<b>Carrier</b> <b>TRANSICOLD</b>	No.: 98-50007-00 Date: 12/17/98	Rev: -
Title: Installation Instructions Access Panel TIR Compliance	Supersedes: new Page: 1 of 1

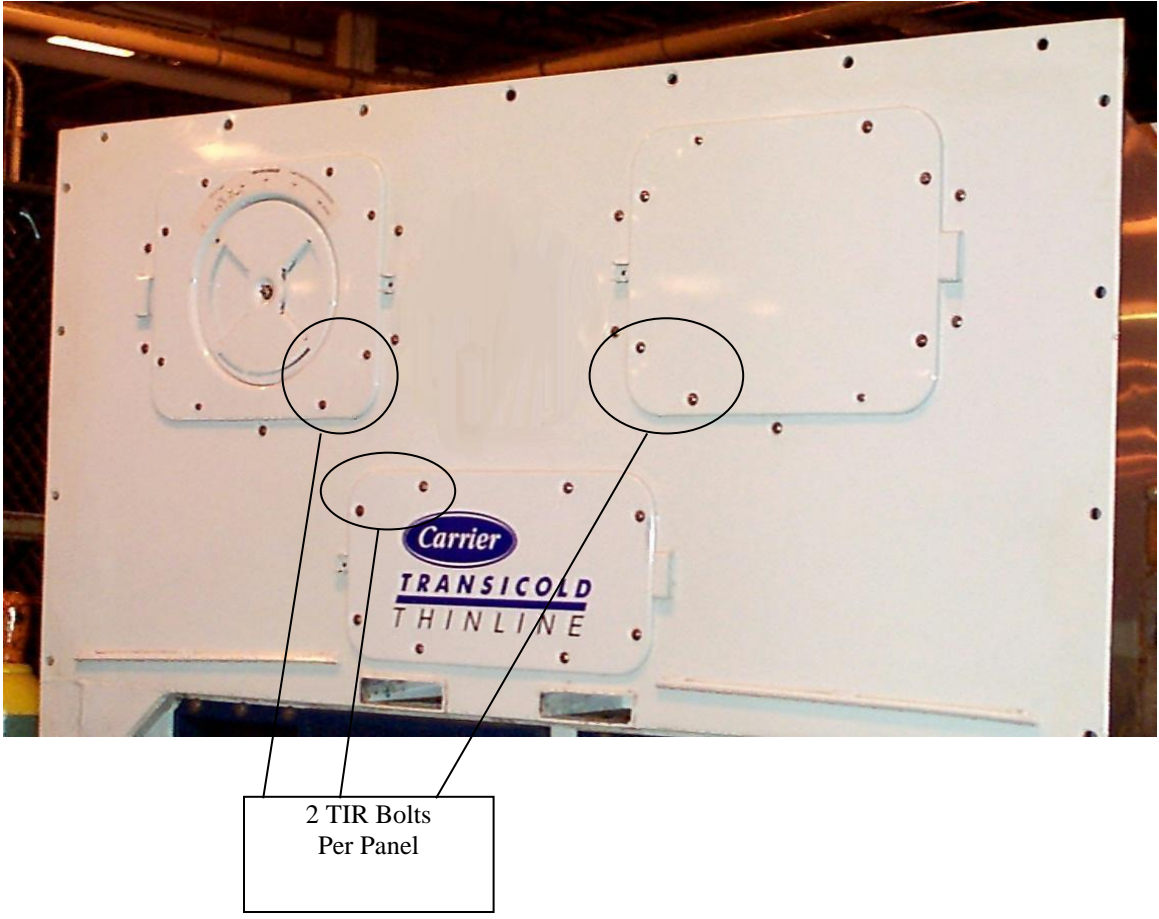
When installing this panel on an older unit originally built with a tabbed TIR seal access panel, please follow the instructions below.

To ensure that the unit continues to comply with TIR customs sealing requirements install two TIR bolts to each access panel (total of 6 per unit) assembled across one corner as shown below.

Newer units with no tabbed panels already have these bolts.
